Please allow us to change the specified range (just given as a rough value) to which the aerosol products can be computed by correcting the overlap effects via the so called overlap function.

In page 4, line 6, please change:

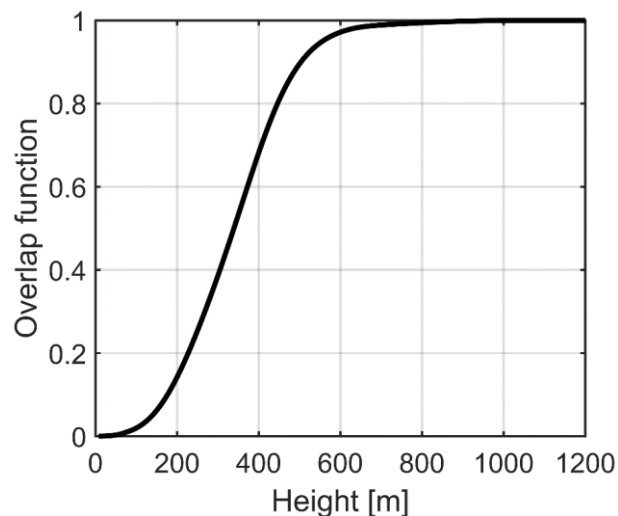
The overlap of the laser beam with the receiver FOV is incomplete for heights below about 1 km above ground level (a.g.l.) and allows for accurate aerosol and cloud profiling for heights above about 500 m a.g.l. only (after the correction of the overlap effects).

For our long term products we are currently using a mean overlap function (experimentally determined) as shown below. Here we see that the full overlap is practically reached at about 800 m and we correct the signal only down to half of this range (400 meters), so that errors in the overlap function carry very little impact on the final product, i.e. the aerosol extinction coefficient. 400 meters is a fair compromise to achieve accurate aerosol products. Again, we do not aim to provide a very accurate value, but 400 is just more accurate.

The overlap of the laser beam with the receiver FOV is incomplete for heights below about 800 m above ground level (a.g.l.) and allows for accurate aerosol and cloud profiling for heights above about 400 m a.g.l. only (after the correction of the overlap effects).
